SUBJECT: CRYSTAL RIVER UNIT 3 - ISSUANCE OF AMENDMENT (TAC NO. 65259)

AMENDMENT TO FACILITY OPERATING LICENSE

Amendment No. 103
License No. DPR-72

ATTACHMENT TO LICENSE AMENDMENT NO.103

Figure 2.1-2
 Reactor Core Safety Limits

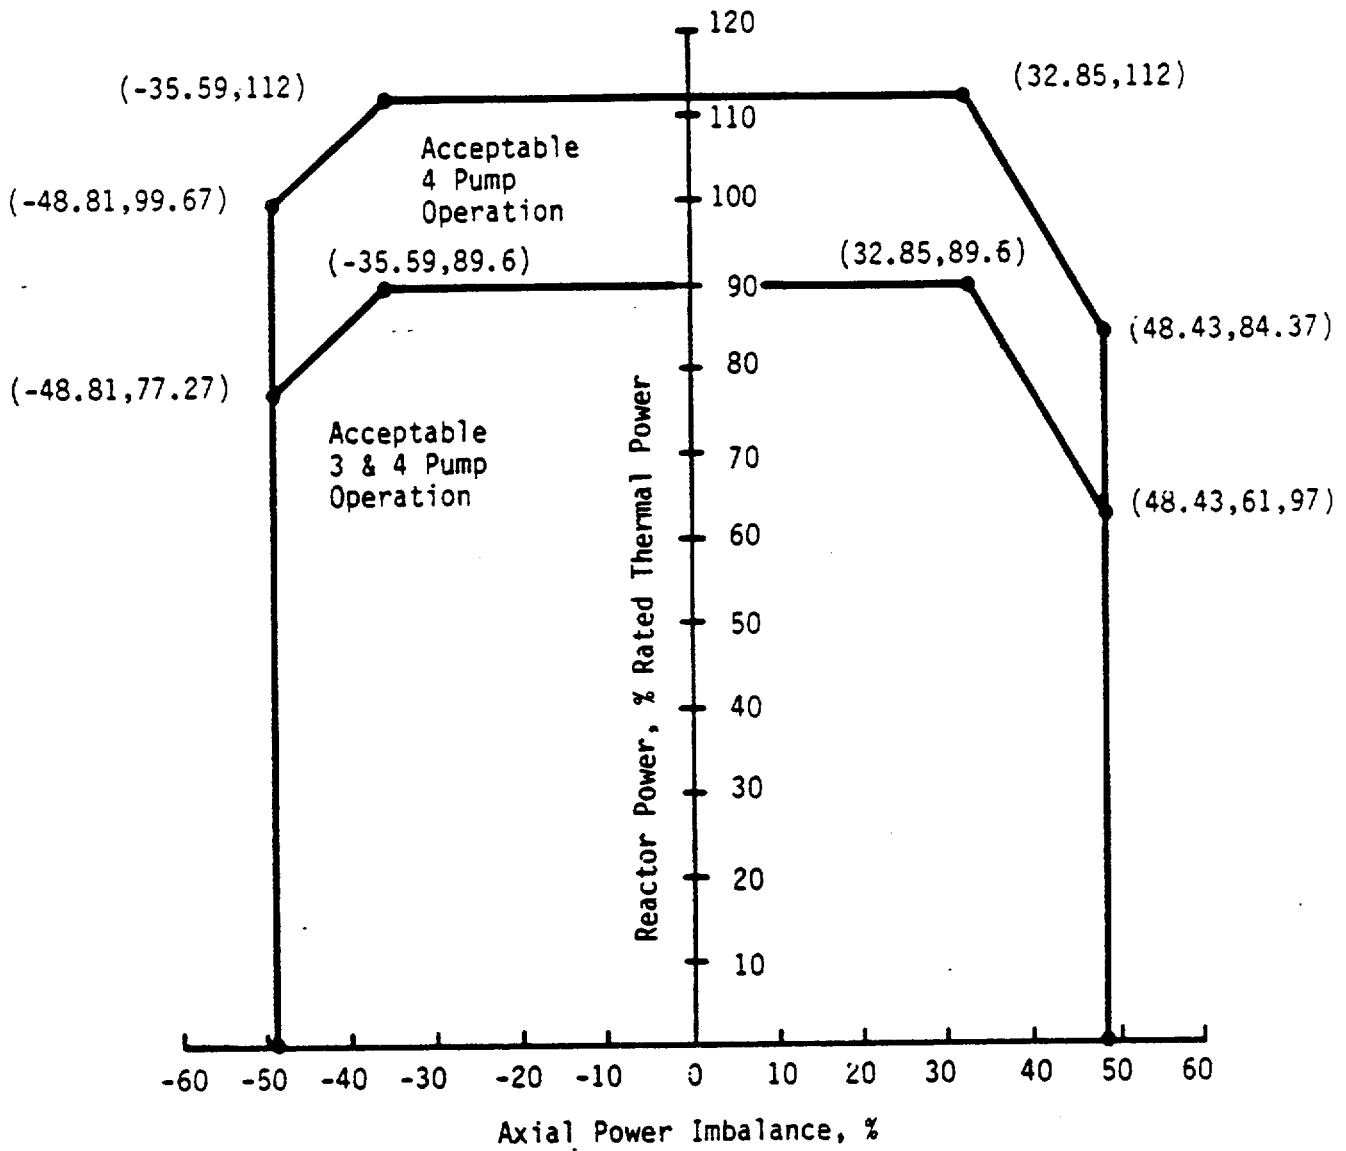
The curves of Figure 2.1-2 are based on the more restrictive of two thermal limits and consider the effects of potential fuel densification and potential fuel rod bow:

The specified flow rates for curves 1 and 2 of Figure 2.1-2 correspond to the expected minimum flow rates with four pumps and three pumps respectively.

Figure 3.1-1

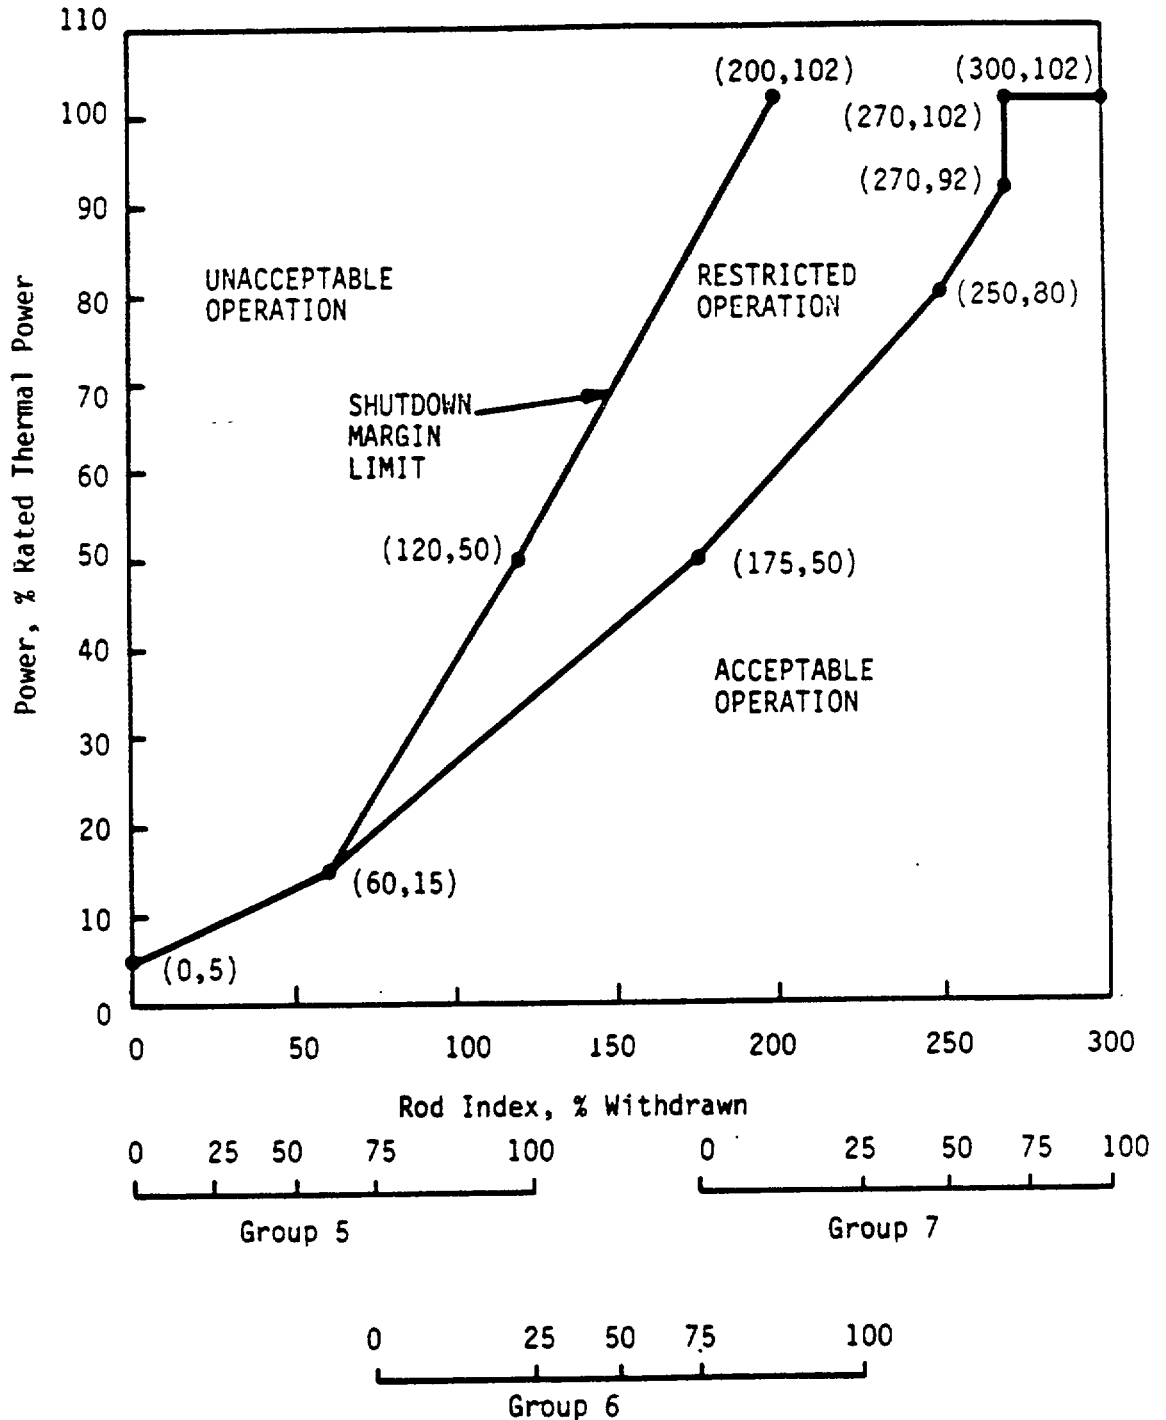
Regulating Rod Group Insertion Limits for Four-Pump Operation From 0 to 500±10 EFPD

Note: This Figure shall be used up to complete APSR withdrawal per Specification 3.1.3.9

Figure 3.1-2

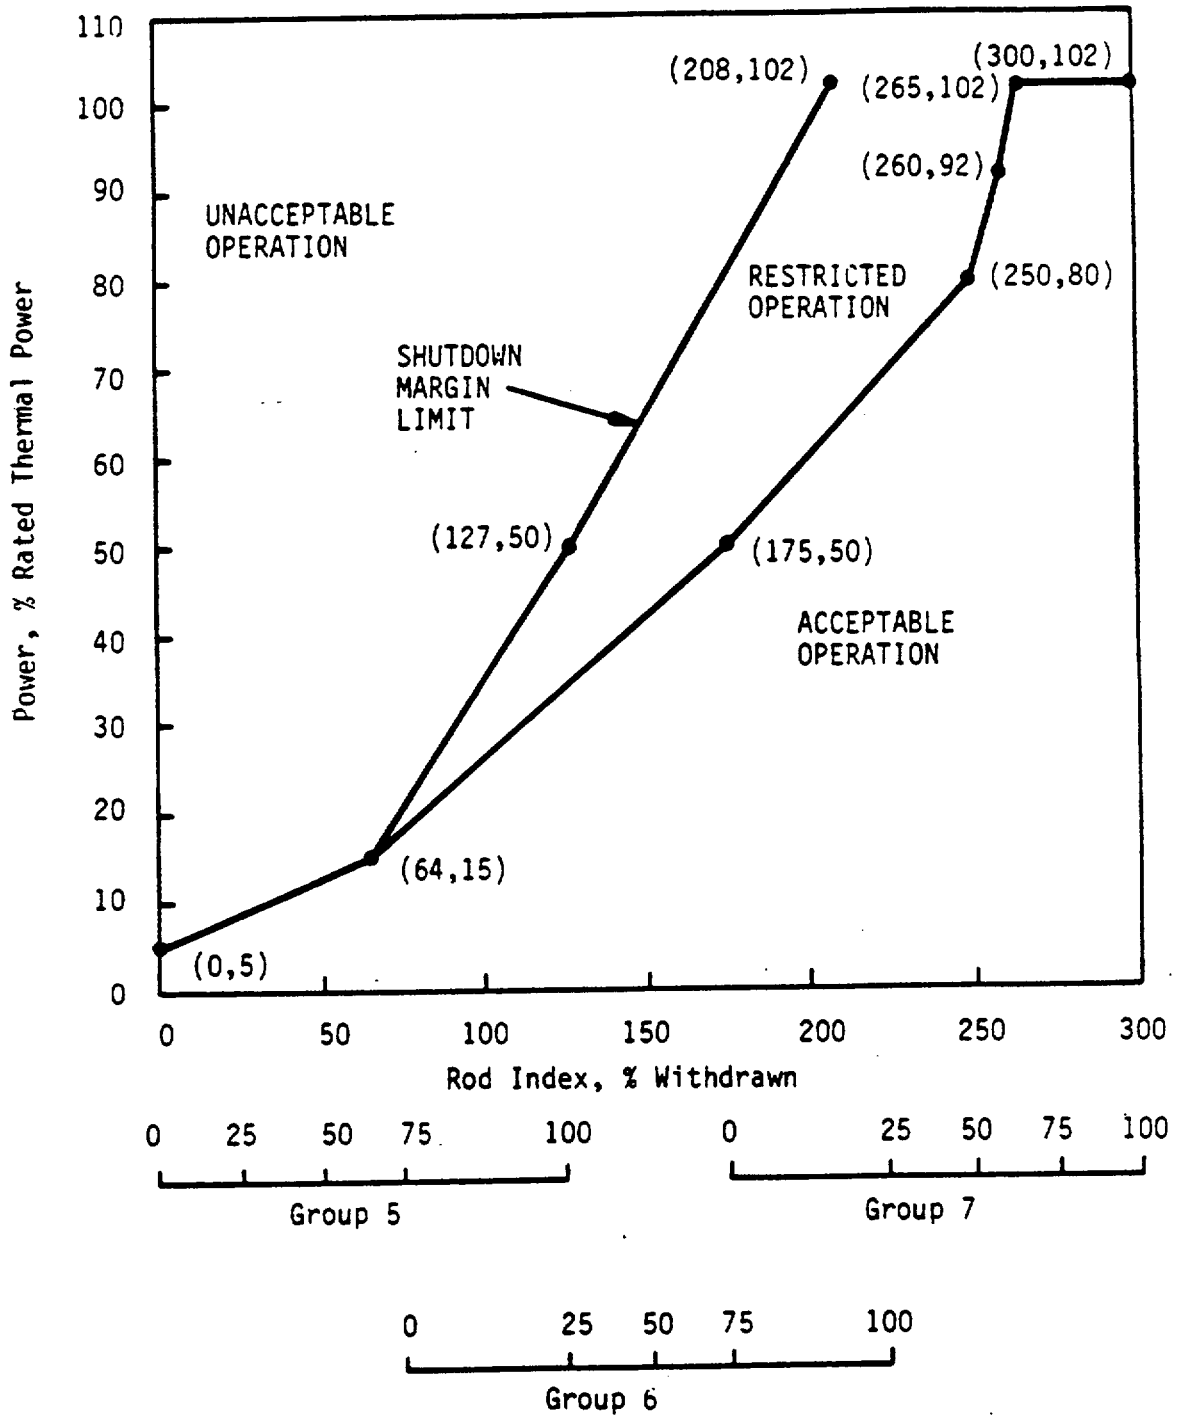
Regulating Rod Group Insertion Limits for Four-Pump Operation After 500+10 EFPD

Note: This Figure shall be used after complete APSR withdrawal per Specification 3.1.3.9

Figure 3.1-3

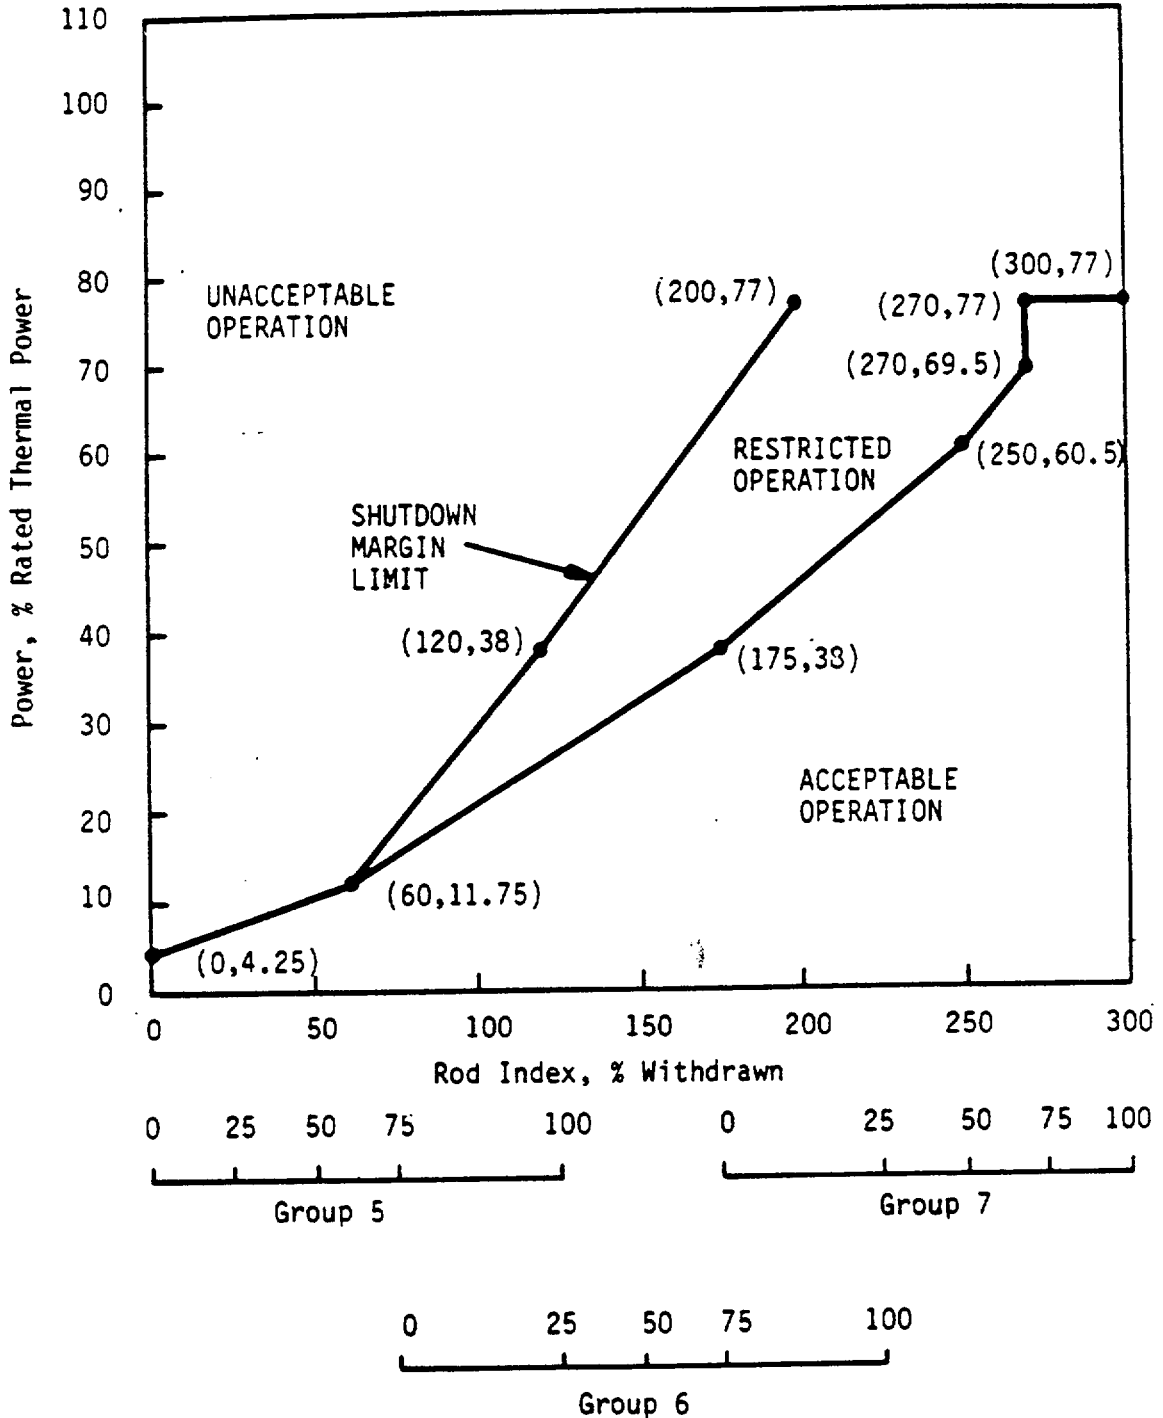
Regulating Rod Group Insertion Limits for Three-Pump Operation From 0 to 500±10 EFPD

Note: This Figure shall be used up to complete APSR withdrawal per Specification 3.1.3.9

Figure 3.1-4

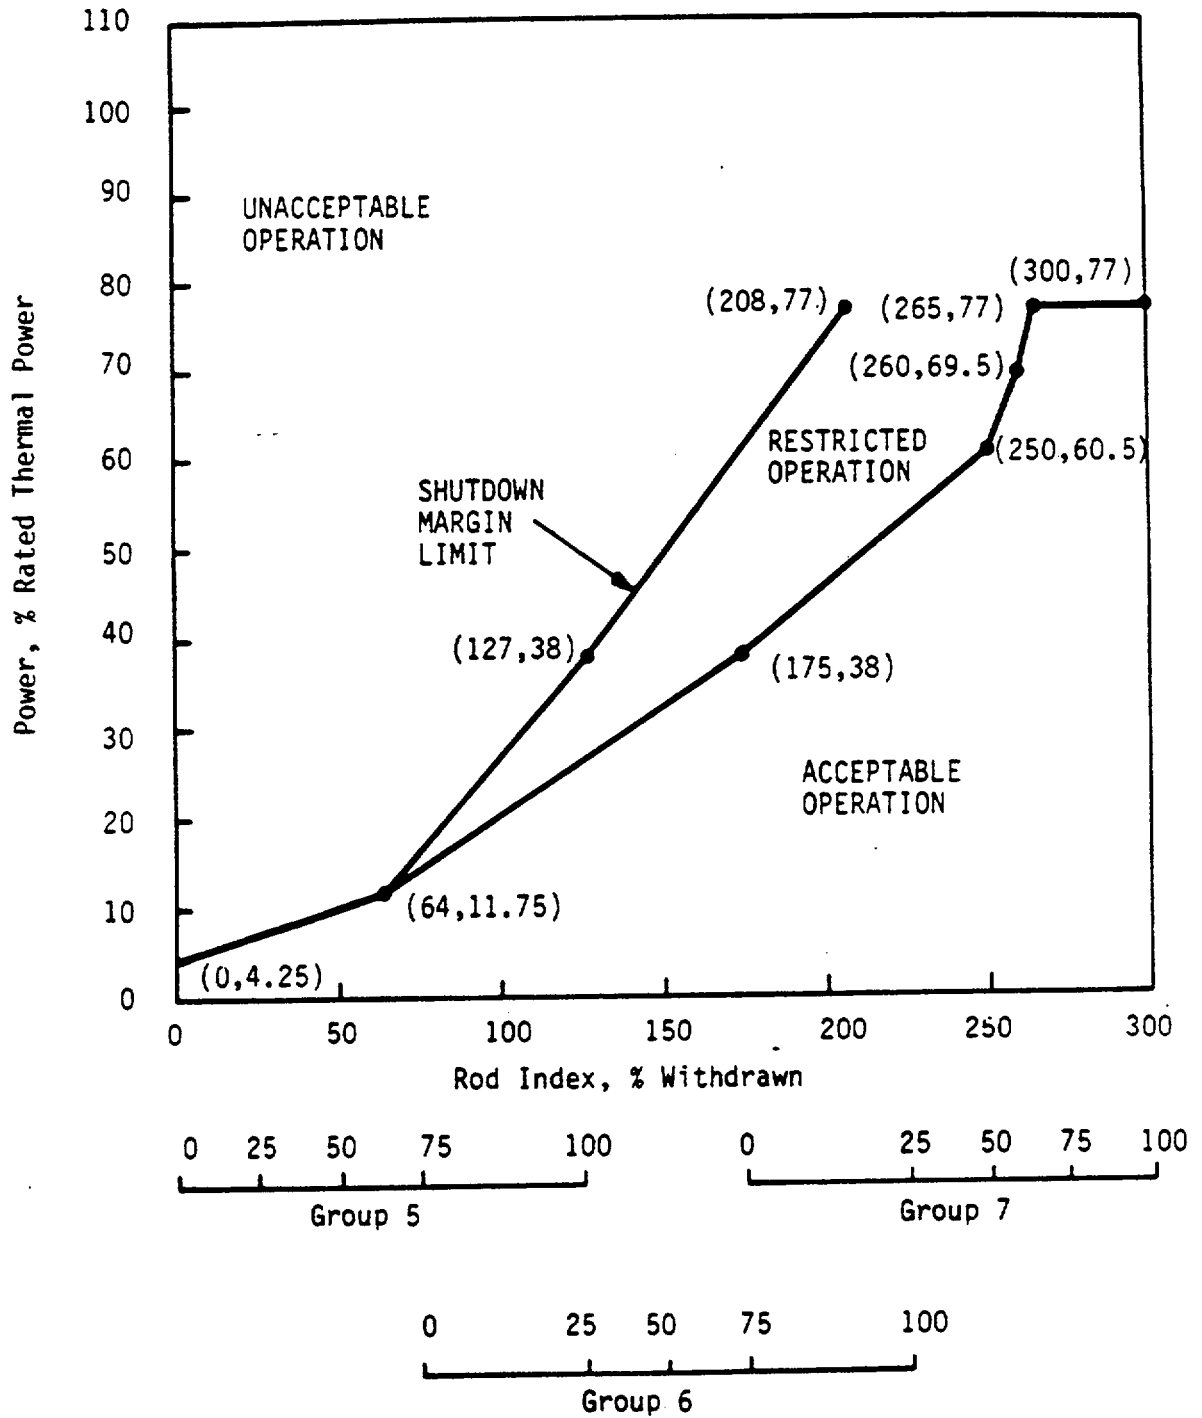
Regulating Rod Group Insertion Limits for Three-Pump Operation After 500+10 EFPD

Note: This Figure shall be used after complete APSR withdrawal per Specification 3.1.3.9

Figure 3.1-7
Control Rod Locations and Group Designations
for Crystal River 3 Cycle 7

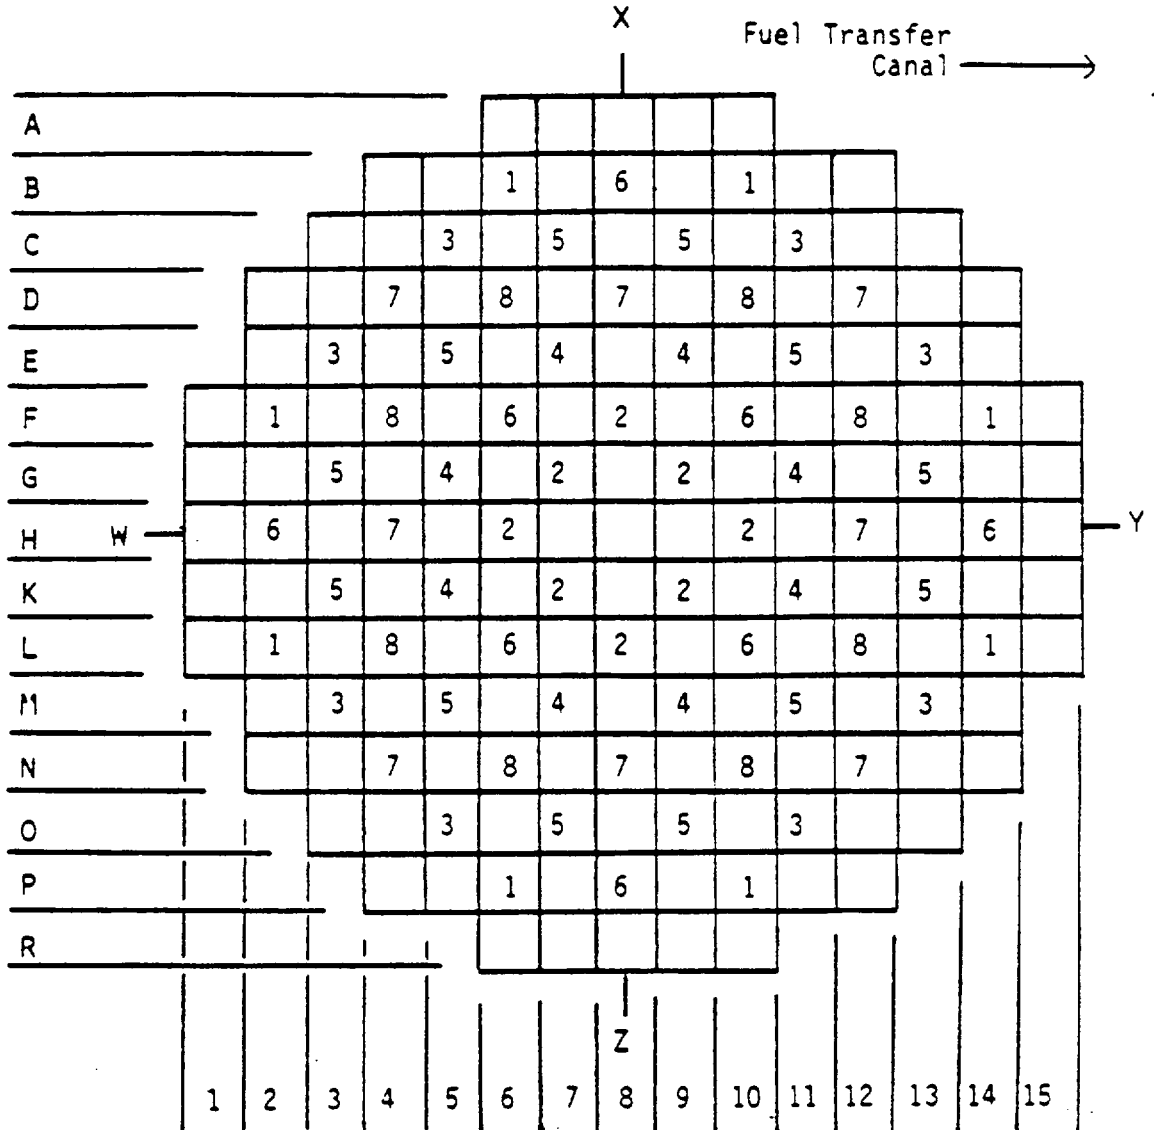
3.1.3.7 Each control rod (safety, regulating and APSR) shall be programmed to operate in the core position and rod group specified in Figure 3.1-7.

Figure 3.2-1
 Axial Power Imbalance Envelope for Four-Pump
 Operation From 0 EFPD to EOC

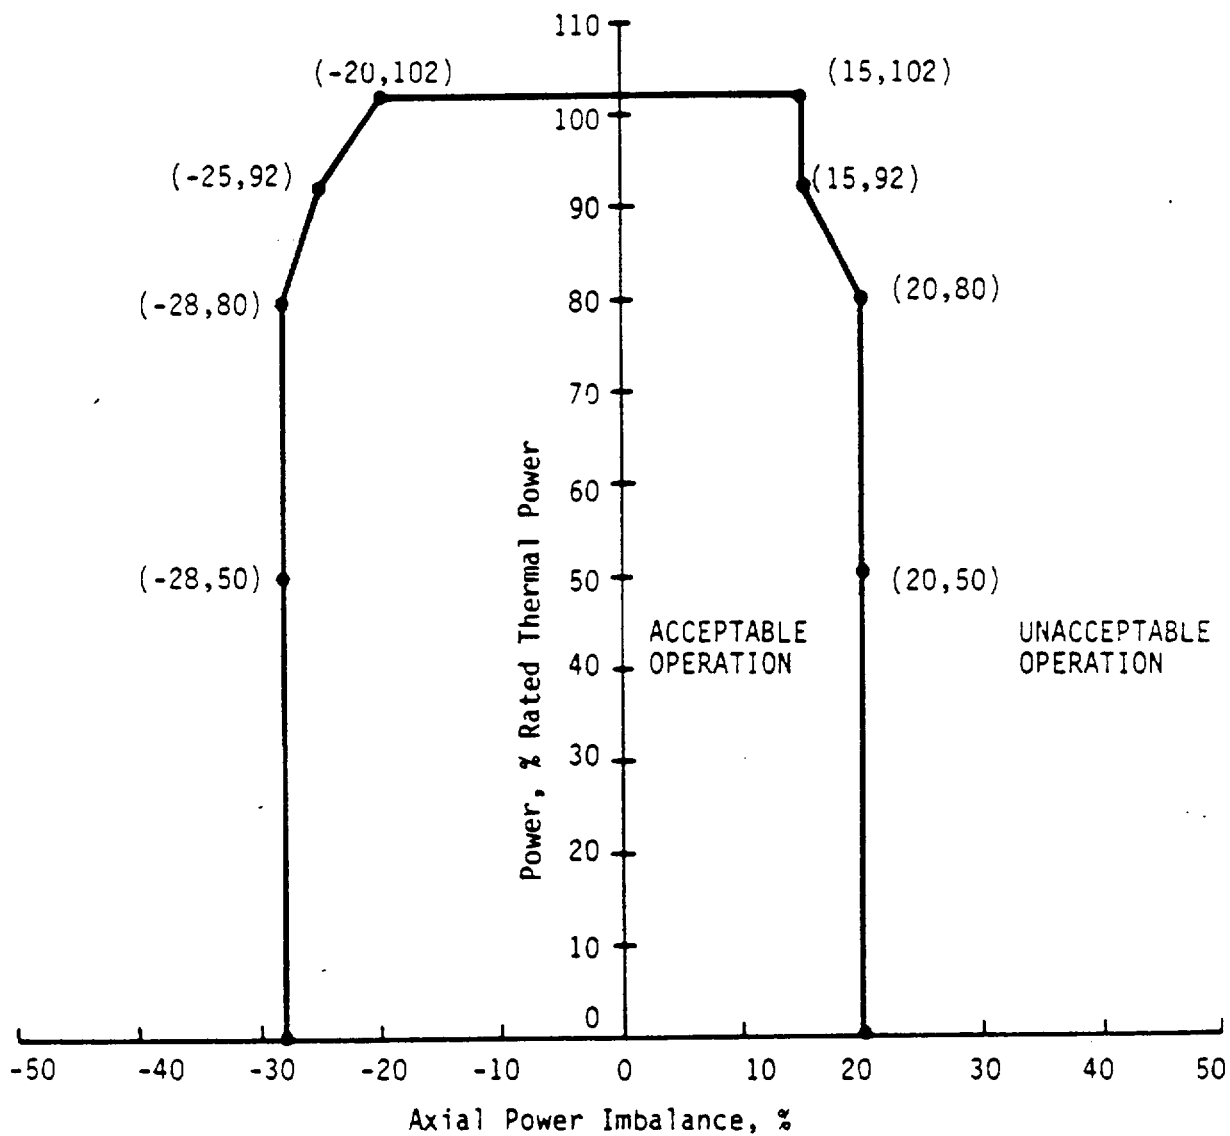
3.2.1 AXIAL POWER IMBALANCE shall be maintained within the limits shown on Figures 3.2-1, and 3.2-2.
